April 25, 2022

Re: **ot 2 A o Inte tate In t a T act /Lot 28-A of Interstate Industrial Tract**
E on St. NE /4000 Ellison St. NE
T a c C c at on a o t
Architect's Stamp 02-24-22 (D17-D074)

DRAINAGE AND TRANSPORTATION INFORMATION SHEET (REV 6-2018)

Project Title: 4000 Ellison Building Permit #: _____ Hydrology File #: _____

1 SITE PLAN -TRAFFIC 1
1" = 30'-0"

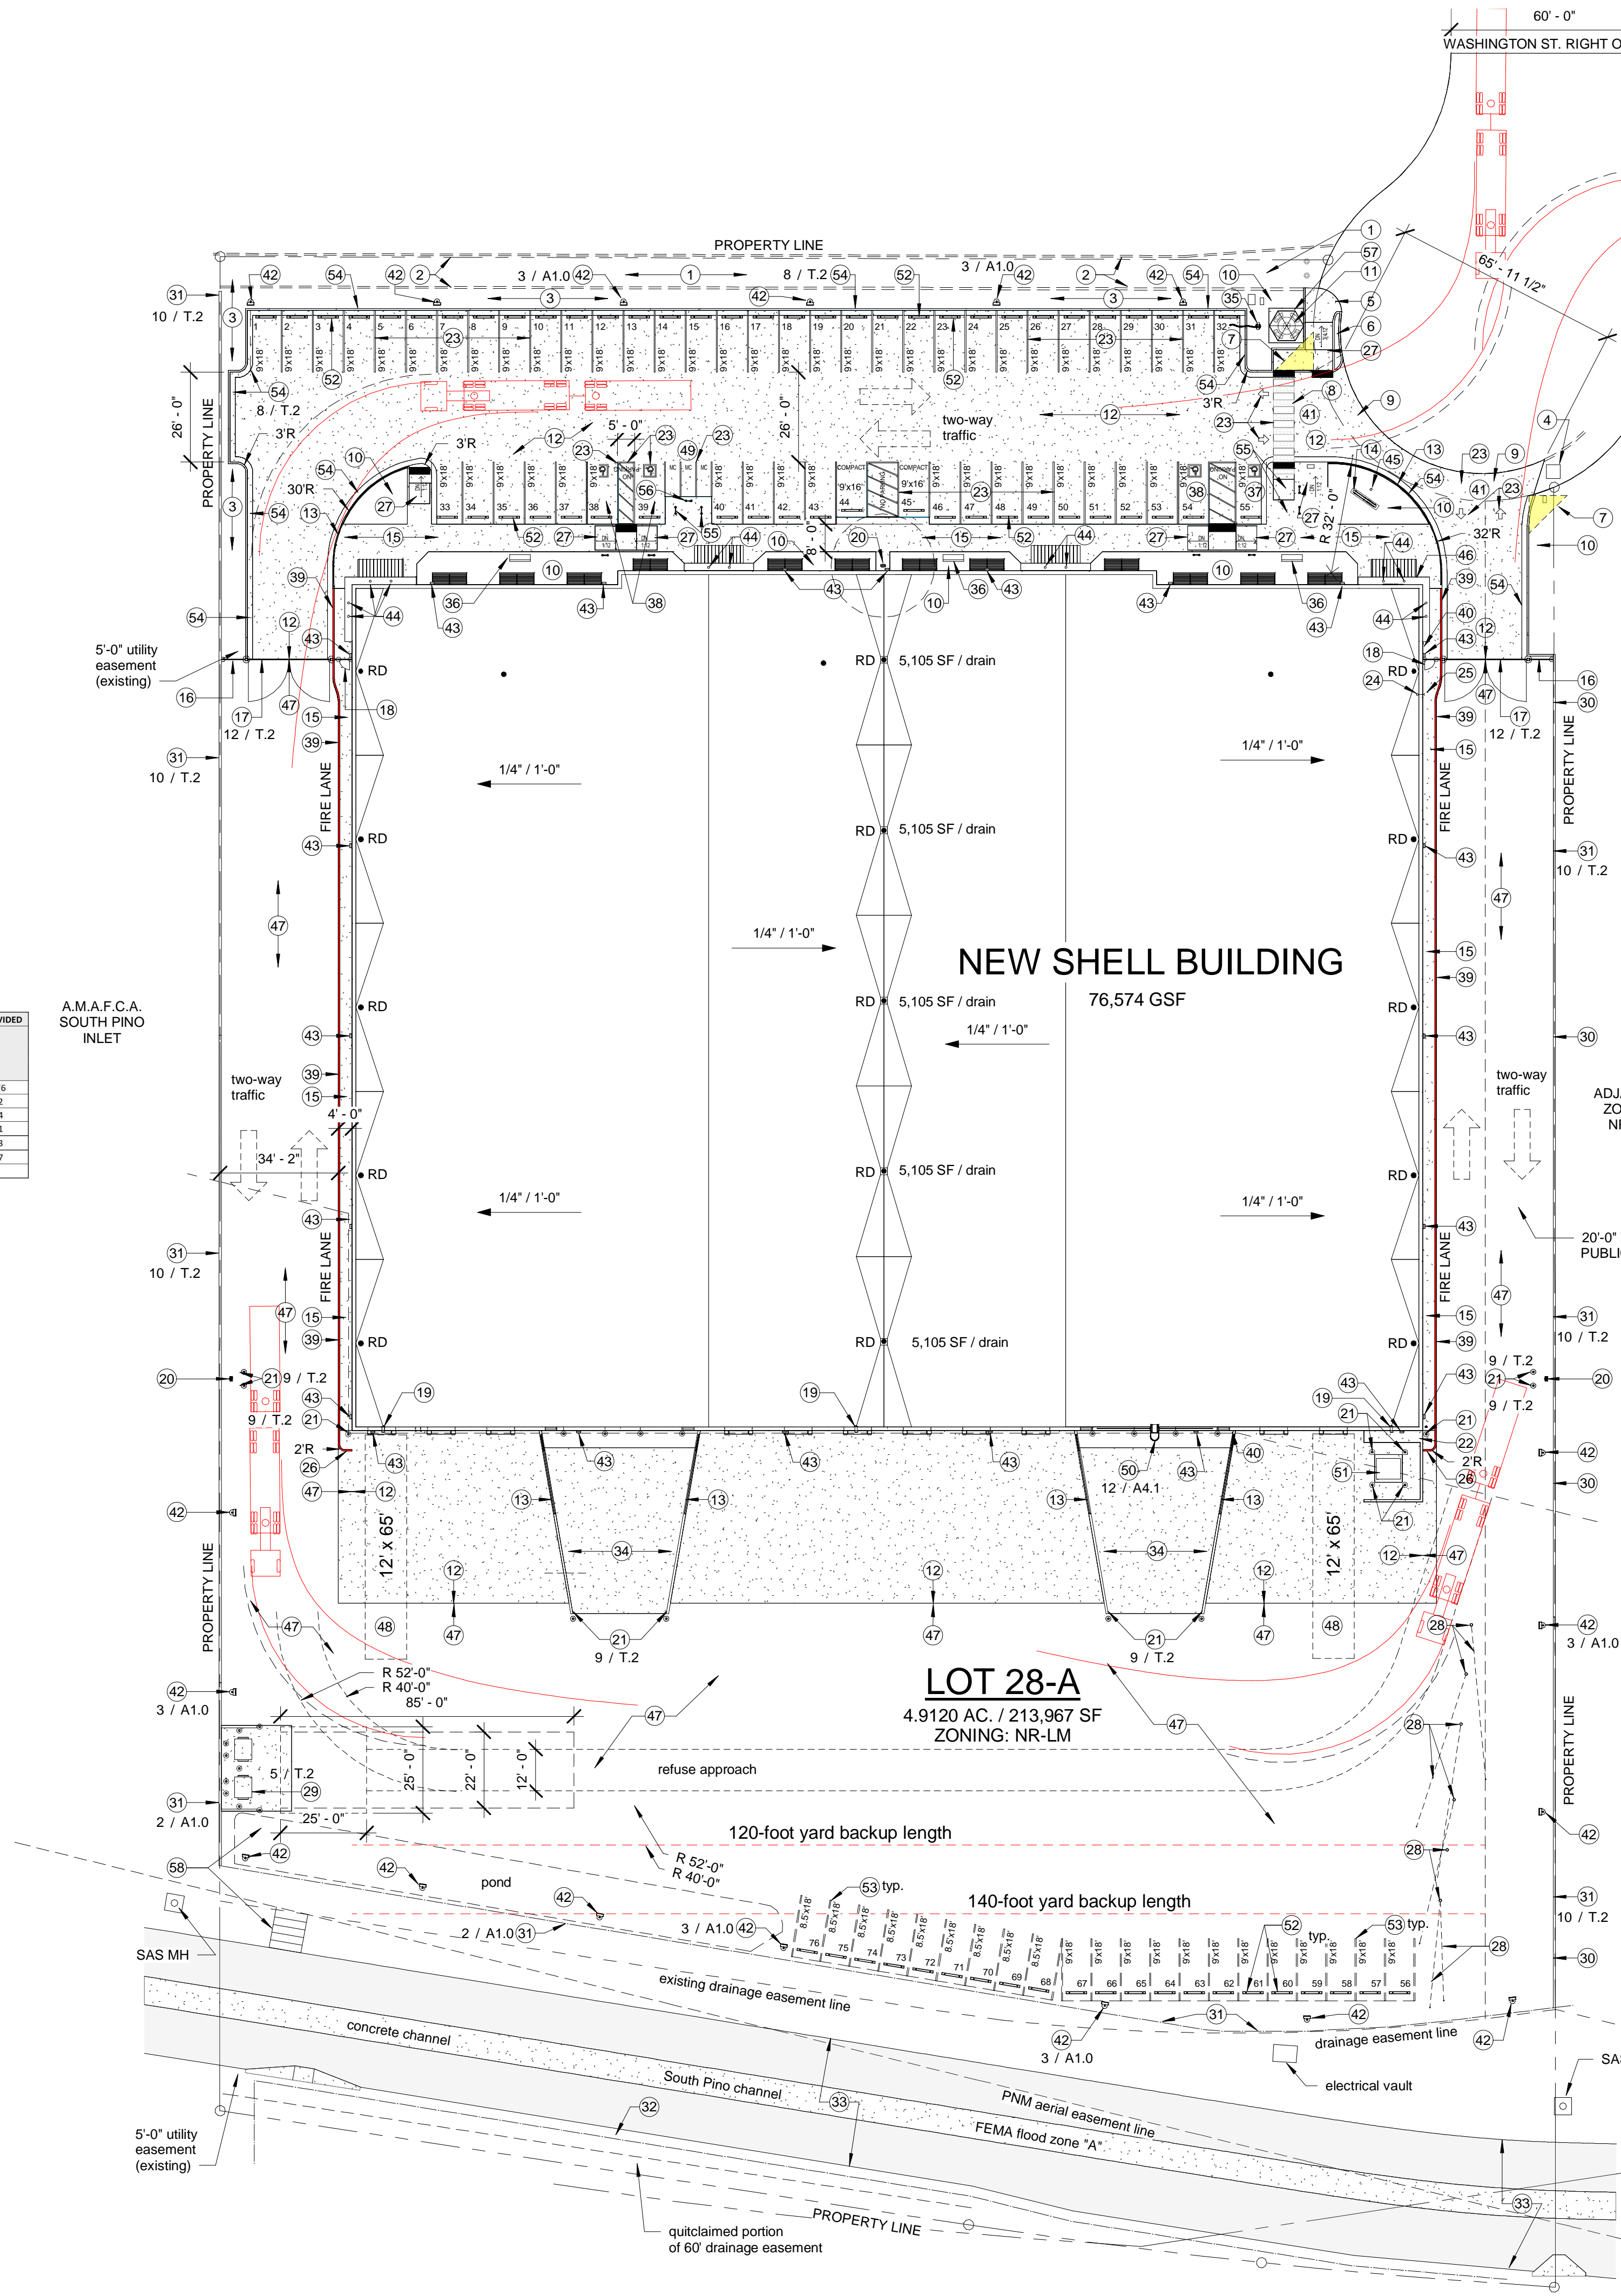
1. Please define the Property Line.
2. Provide both site accesses' width, radius, all details, and call out COA std dwg.
3. Maximum access width for arterial, collector, and local streets are as follows:

4. Provide the west and the northwest drive aisles' width.
5. Label the compact parking spaces by placing the words **COM ACT** on the pavement of each space.
6. The minimum drive aisle dimensions are shown below

7. List radii for all curves shown; for passenger vehicles. Radius for delivery trucks, fire trucks, etc. is 25 ft. or larger.
8. A 5 ft. keyway is required for dead-end parking aisles.

9. Per the IDO, a 6 ft. wide ADA accessible pedestrian pathway is required from the public sidewalk to the building entrances. Please clearly show this pathway and provide details.

10. Per DPM, a 6 ft. wide ADA accessible pedestrian pathway is required from the ADA parking stall access aisles to the building entrances. Please clearly show this pathway and provide details.

11. ADA accessible pedestrian pathway should not be placed behind parking space or adjacent to a vehicular way. Vehicle and pedestrian/wheel chair conflicts should be avoided as much as possible.

12. Refuse vehicle maneuvering shall be contained on-site. The refuse vehicle shall not back into the public right of way.; provide a copy of refuse approval.

Arterial& Collector	Local Streets
One-way Drive	20'-25'	12'-20'
Two-Lane Drive	22'-30'	22'-24'
Three-Lane Drive	24'-35'	22'-30'
Larger Vehicles	≤50'	≤30'

Minimum Drive Aisle Width
Two Way Traffic	22'
Main Circulation Road	24'
Fire Lane	20'
